Room Media Controller: QM-RMC

Correction to “Establishing Communication with the QM-RMC”

**Addendum #1 for DOC. 6161
09.03**

Example of Viewport Message – No Program Loaded

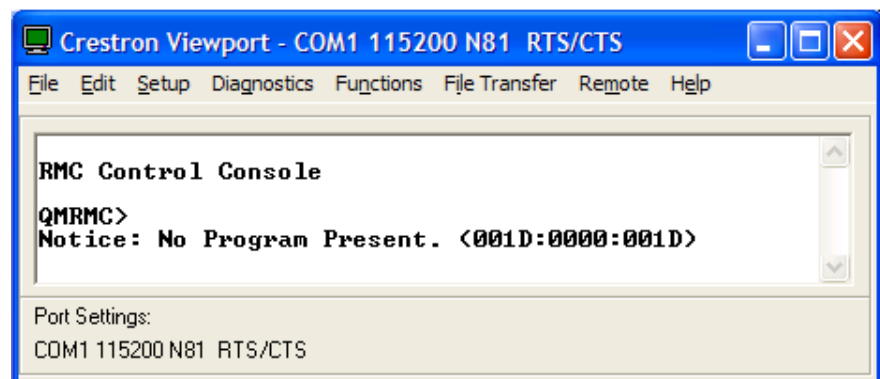
The purpose of this addendum is to provide additional information not supplied with the original QM-RMC Operations Guide (Doc. 6161). Specifically, this addendum corrects the procedure for establishing the serial console connection with Viewport using the SW-R button. This procedure appeared on page 11.

Serial console connection may be established only if SW-R button is pressed **and held about 5 to 7 seconds** during power up (**wait for Viewport to display some information**), or if pressed and held at the same time HW-R is momentarily pressed.

NOTE: The COM B LED will flash when in the console mode.

To terminate the console mode, press the HW-R button or cycle the power.

NOTE: Pressing **F10** (Program Reset) in Viewport may cause errors if both the program and the console mode are using the same COM port
